To: Plan Holders for Improvements to the  
Washington County Airport  
Mineral Point, Missouri  
MoDOT Project No. 24-060A-1 & 24-060A-2

Transmitted herewith is **Addendum No. 1** to the Issued for Bid Contract Documents, Specifications and Plans dated May 28, 2024, for Improvements to the Washington County Airport.

**ADDENDUM NO. 1  
TO  
CONTRACT DOCUMENTS, SPECIFICATIONS AND PLANS  
FOR IMPROVEMENTS TO THE  
WASHINGTON COUNTY AIRPORT  
MINERAL POINT, MISSOURI  
MODOT PROJECT NO. 24-060A-1 & 24-060A-2**

C TYPICAL SECTION - TAXIWAY A AND B  
NOT TO SCALE

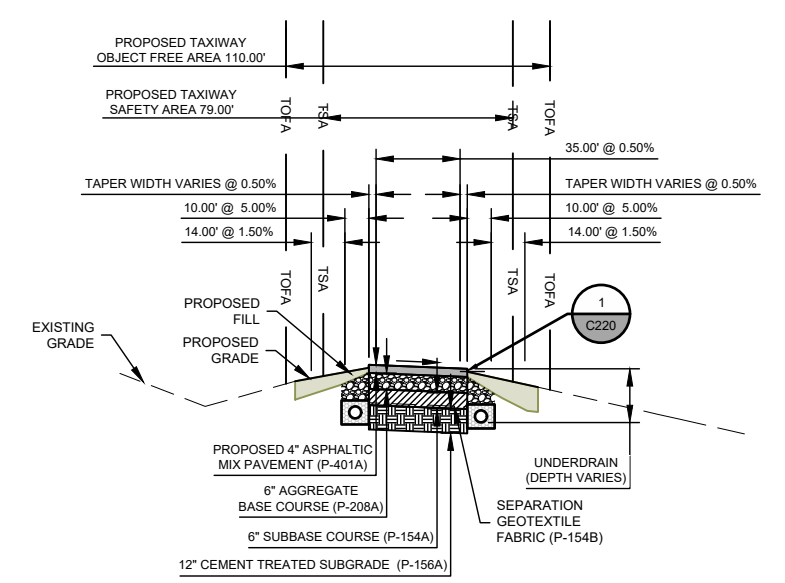
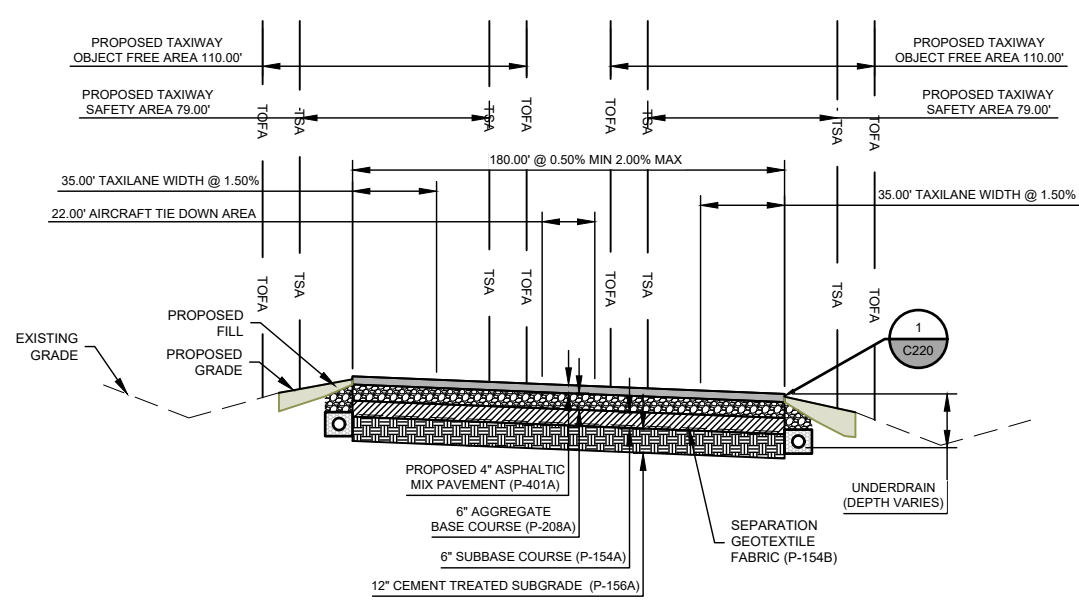
**Revision:** This sheet has been added.

**Justification:** The typical sections for the taxiways and apron have been included as part of this sheet.

UNDERDRAIN PLAN STA. 0+00 TO 4+50 RUNWAY 2/20		SHEET NAME C500
MoDOT PROJ. NO. 24-060A-1 & 24-060A-2	WOOLPERT PROJ. NO. 1015274	
		SHEET NO. 79 of 145

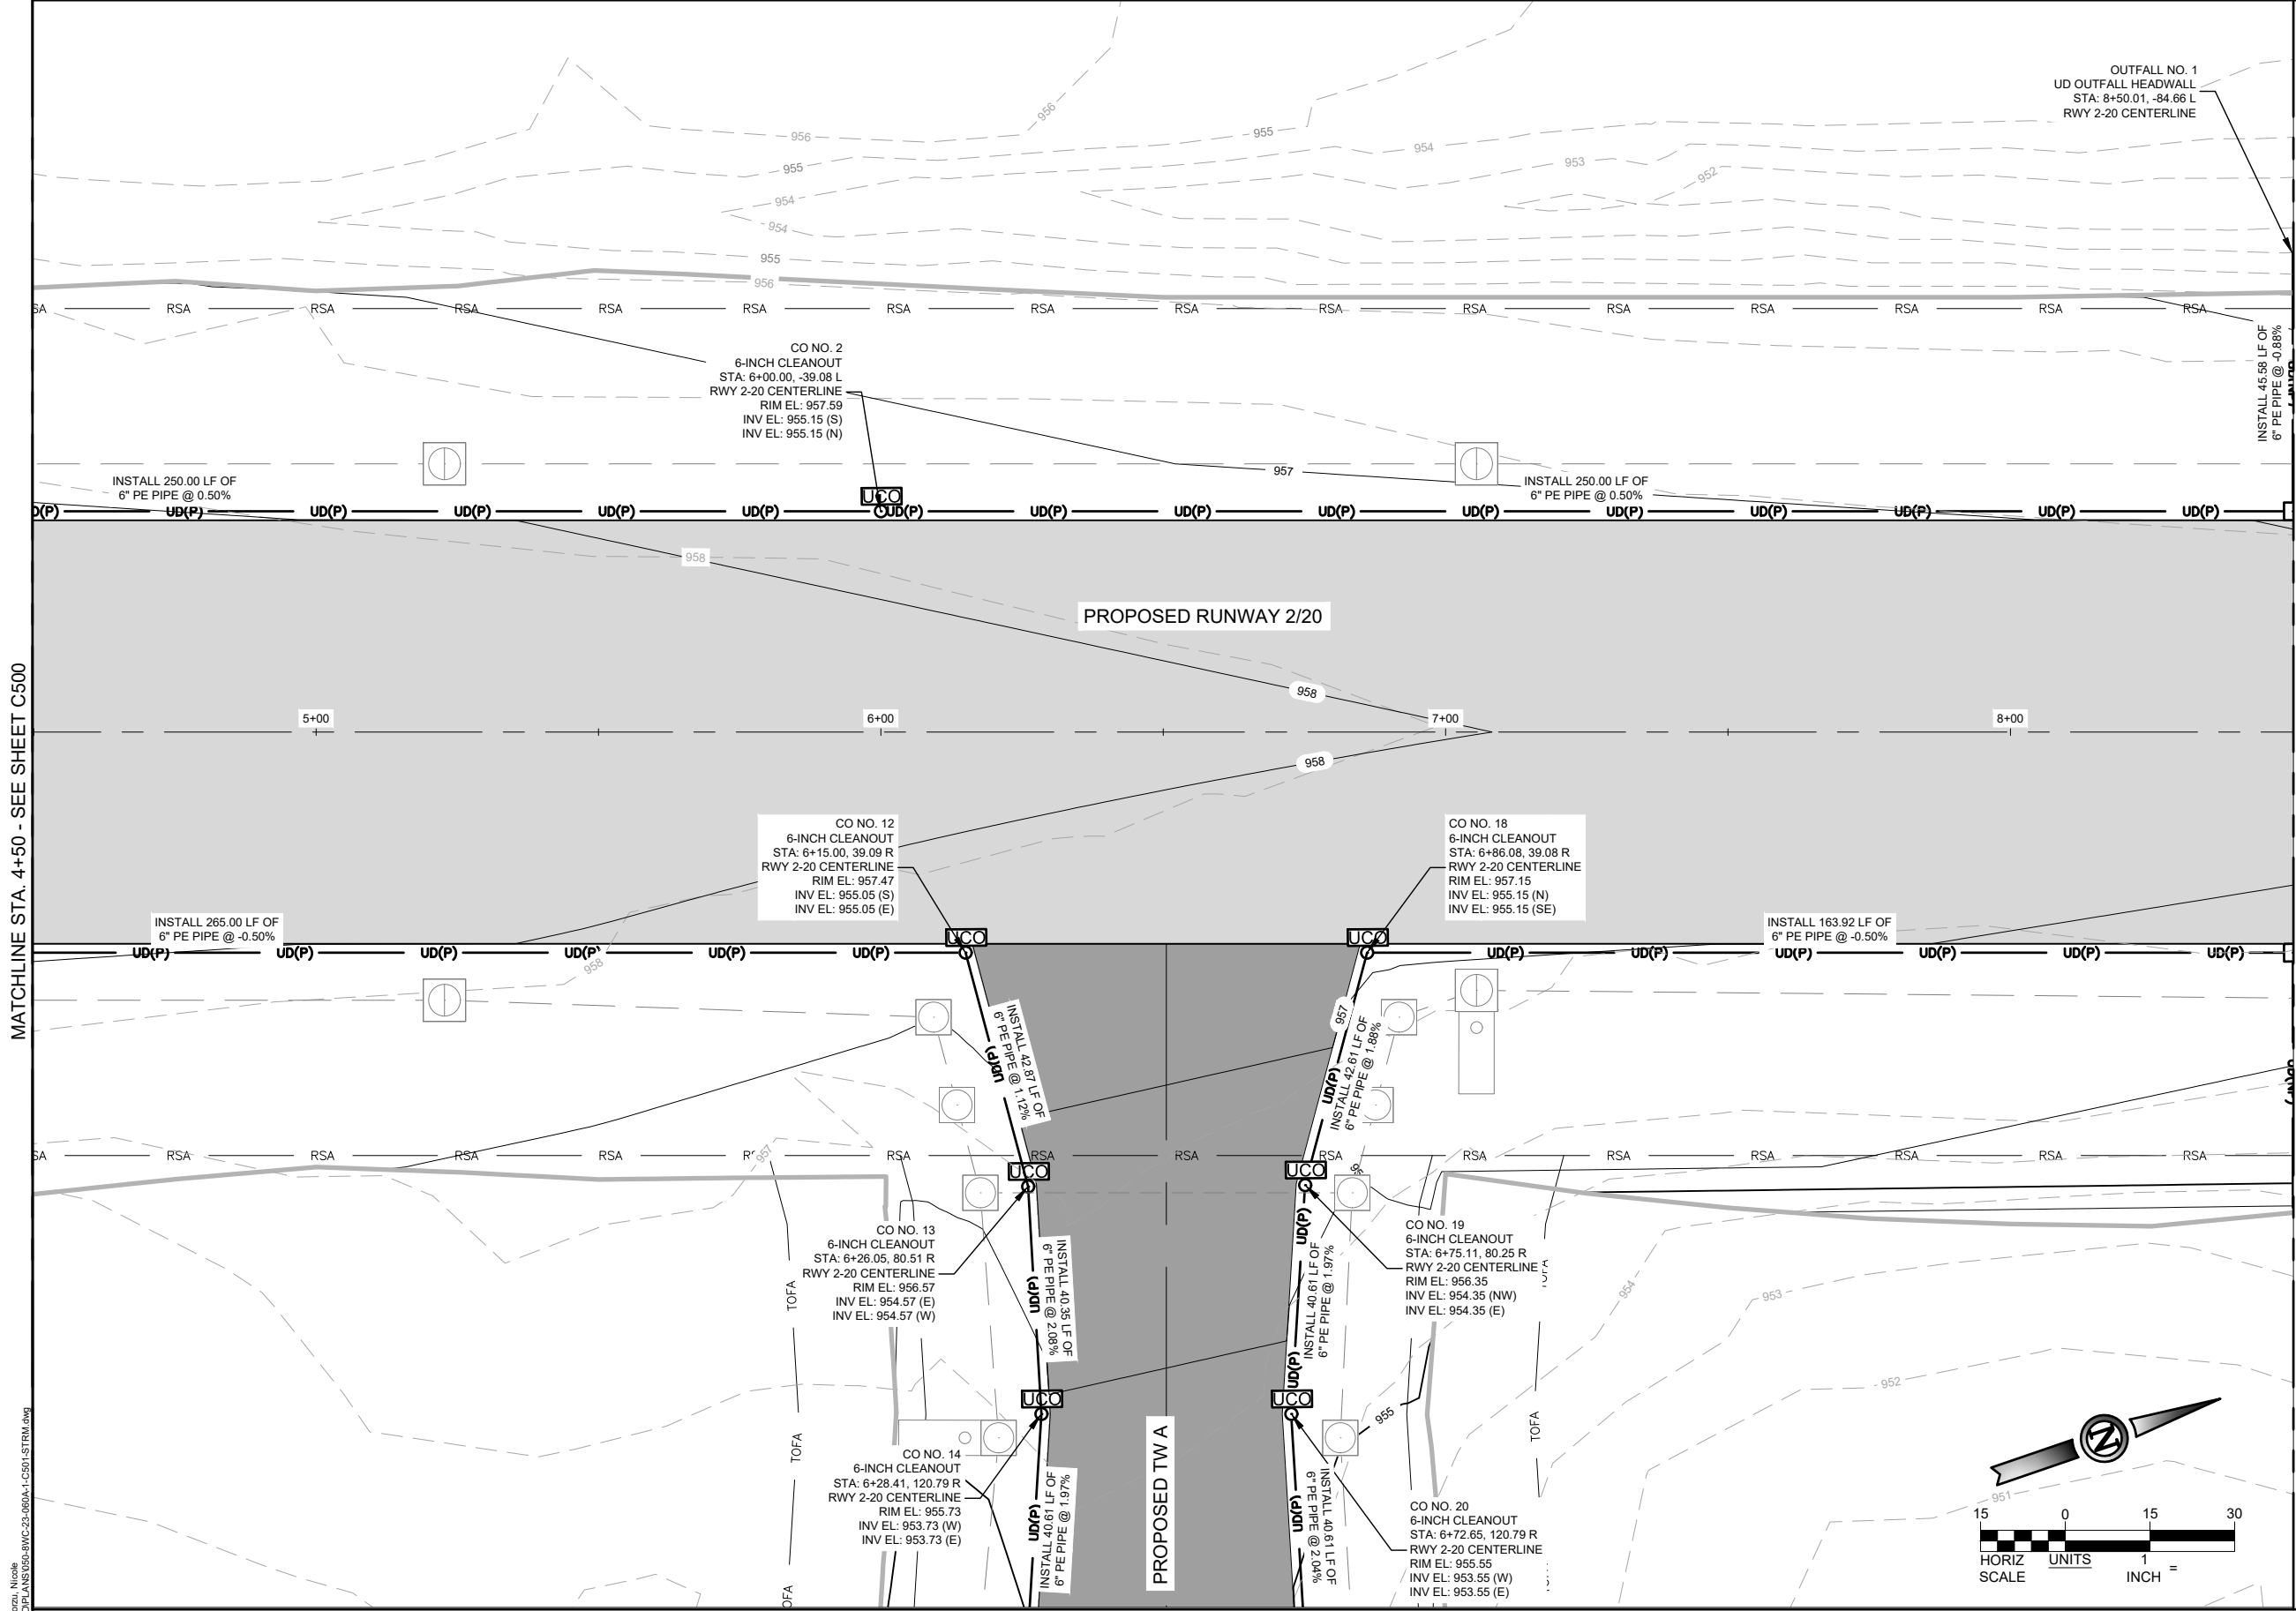
**C500 - (79 of 145) Underdrain Plan, STA. 0+00 to 4+50, Runway 2/20**

UNDERDRAIN PLAN STA. 20+50 TO 24+50 RUNWAY 2/20		SHEET NAME C505
SHEET NO. 84 of 145		
MoDOT PROJ. NO. 24-060A-1 & 24-060A-2	WOOLPERT PROJ. NO. 1015274

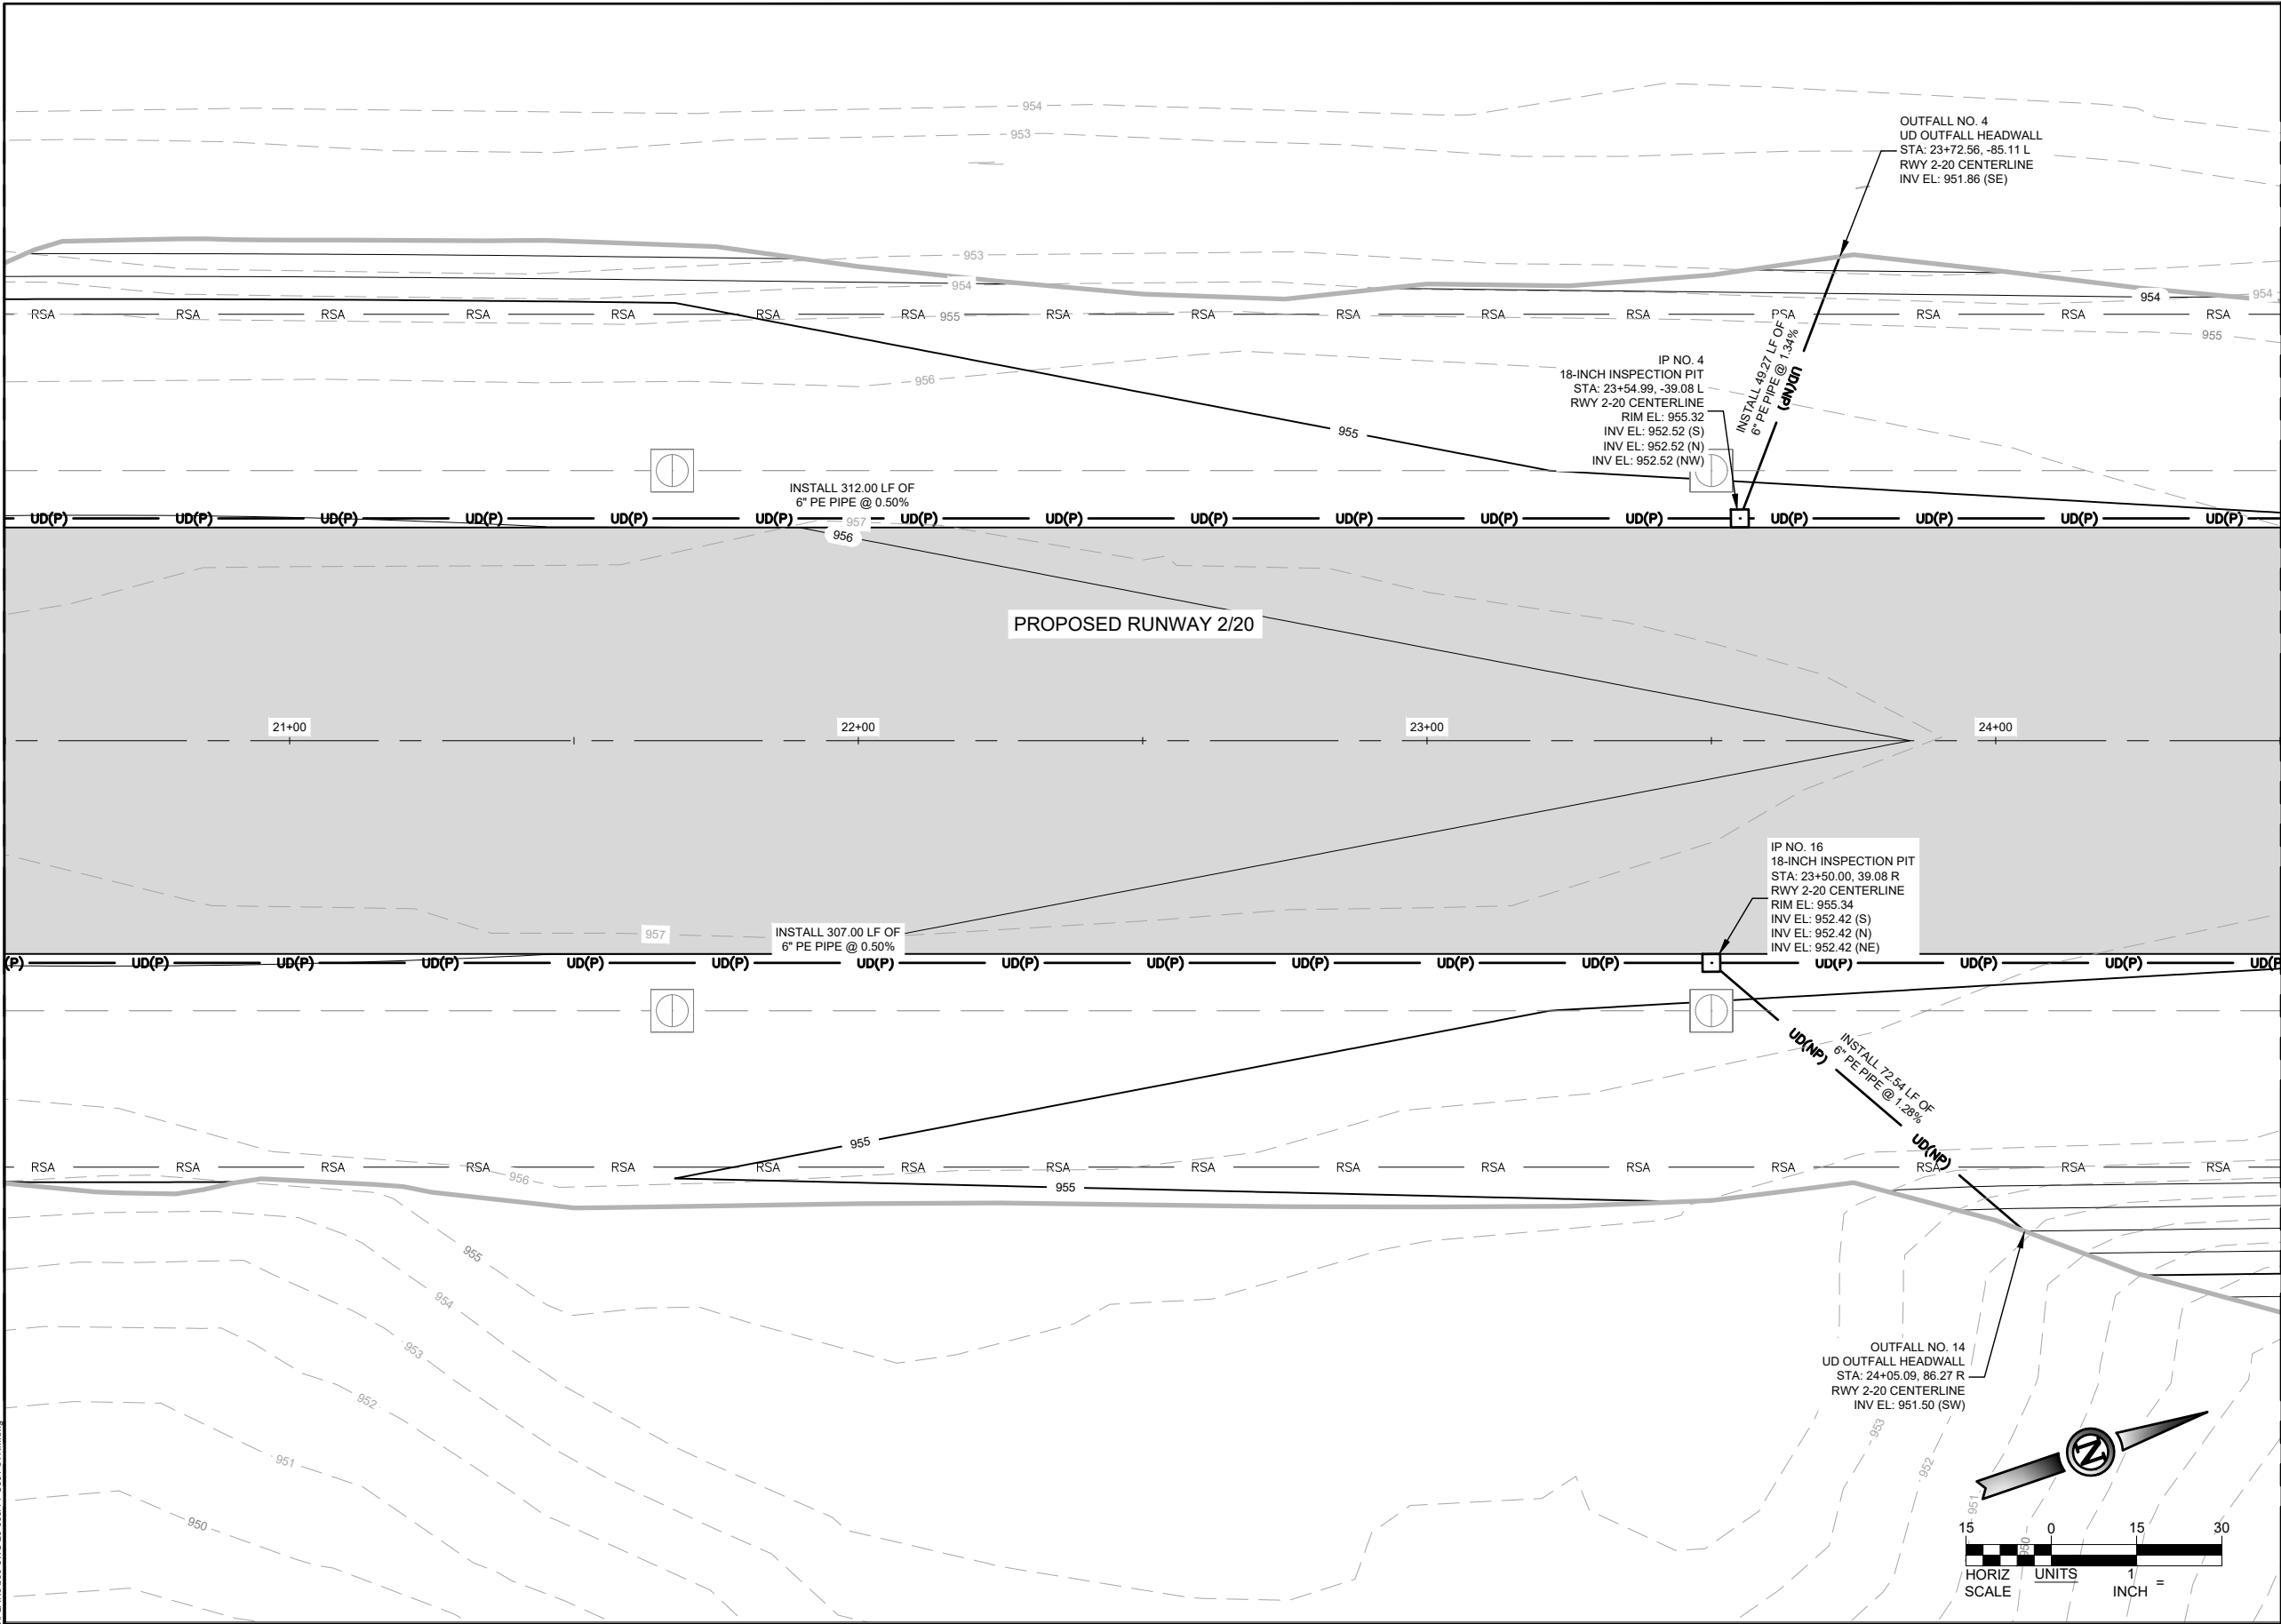
**C505 - (84 of 145) Underdrain Plan, STA. 20+50 to 24+50, Runway 2/20**
